VIRGINIA ELECTRIC AND POWER COMPANY (DOMINION)
NORTH ANNA POWER STATION UNITS 1 AND 2
PROPOSED TECHNICAL SPECIFICATIONS CHANGES AND EXEMPTION
REQUEST FOR USE OF FRAMATOME ANP ADVANCED MARK-BW FUEL
REQUEST FOR ADDITIONAL INFORMATION PERTAINING TO THE ICECON
MODULES IN THE REALISTIC LARGE BREAK LOCA (RLBLOCA)

**Request for Additional Information
ICECON Module for Containment Pressure Analysis**

**Virginia Electric and Power Company
(Dominion)
North Anna Power Station Units 1 and 2**

Figure 1 North Anna Unit 2 Case-Independent Containment Pressure Comparison

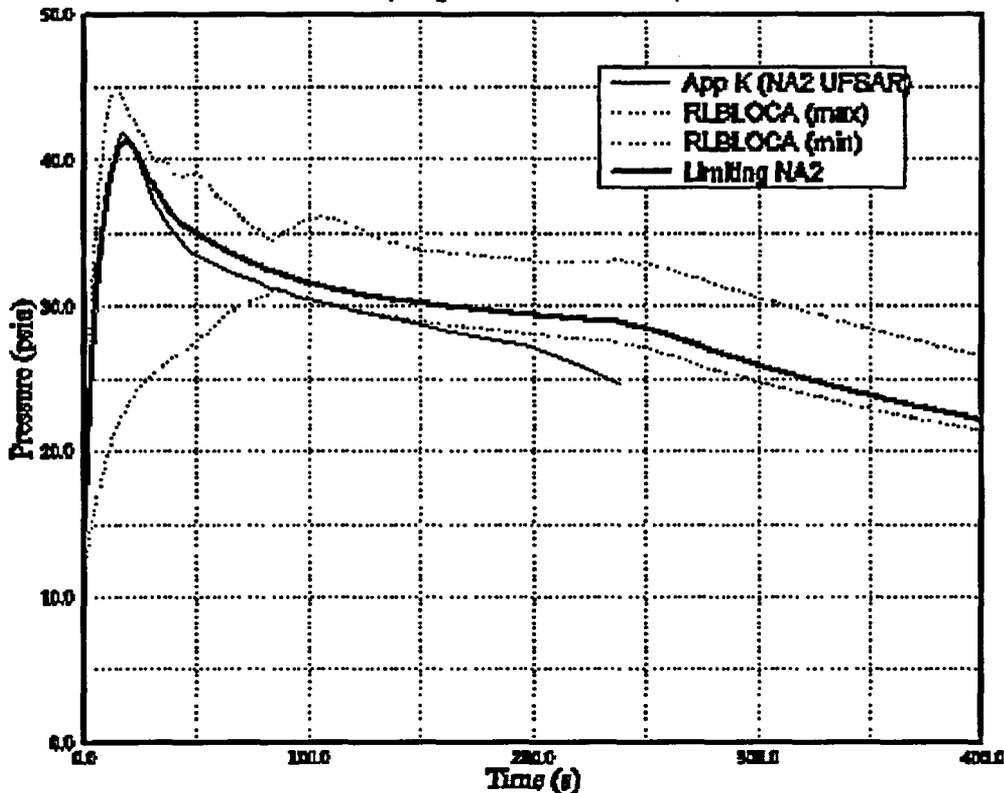
Supplemental Request: In a September 15, 2003 teleconference, NRC staff requested that results be provided to aid in demonstrating that the containment response obtained from the North Anna RLBLOCA analysis encompassed results obtained from an Appendix K-type minimum containment pressure analysis. It was determined that this could be accomplished by providing results from the North Anna Units 1 and 2 analyses that are analogous to that presented in response to RAI Question 26 on the RLBLOCA topical EMF-2103. Responding to this supplemental request eliminates the need to respond to Question 7 through 10 and Question 12.

Supplemental Response: *Figure 1 presents the containment pressure range (case-independent) from the North Anna Unit 2 RLBLOCA case set, the UFSAR (Appendix K-type) minimum containment backpressure prediction, and the containment backpressure from the limiting Unit 2 RLBLOCA case. This comparison indicates that the containment conditions, modeled in accordance with the EMF-2103 methodology, encompass a wide range of pressures, with the limiting Unit 2 case appearing near, but not at the most extreme (i.e., low pressure) value. This comparison provides insight into the relationship between ranged parameter values and PCT results from the RLBLOCA methodology. It indicates that the most limiting of the RLBLOCA PCT cases does not, in general, exhibit a value for any single ranged parameter that coincides with the most extreme value in the parameter sampled range. This is an inherent feature of the RLBLOCA methodology, and in relation to containment pressure, is distinctly different from the 10CFR50 Appendix K approach of using inputs obtained from performing a minimum backpressure analysis. Figure 1 also indicates that the containment pressure predicted from the RLBLOCA calculations encompasses a significant portion of the predicted Appendix K behavior, although this is not a requirement of the methodology.*
